Attachment C

TO: Matt Fanning
FROM: Cham Herath / Sol Friedman
DATE: 22nd January 2016

TRANSPOWER WIL-CPK B LINE RE-CONDUCTORING SUBMISSION

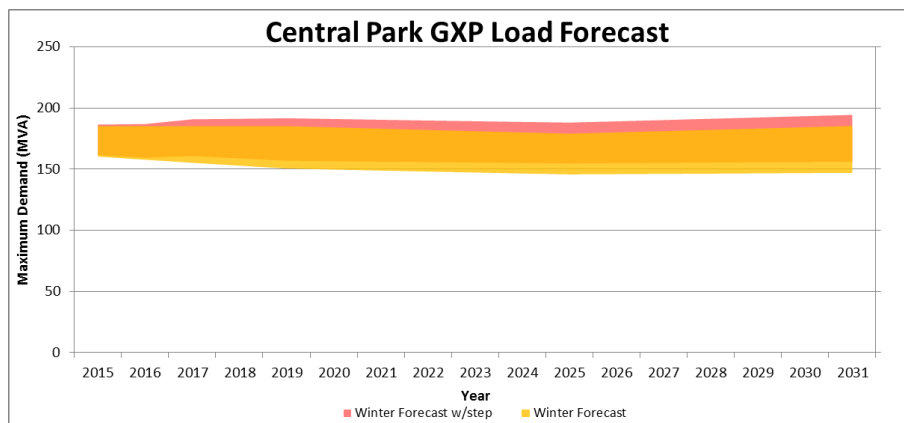
As shown below, WE* has a lower demand forecast than Transpower, because it uses a different forecasting methodology and assumes less growth than Transpower does.

Wellington Electricity and Transpower have differing load forecasts due to the individual methodologies adopted.
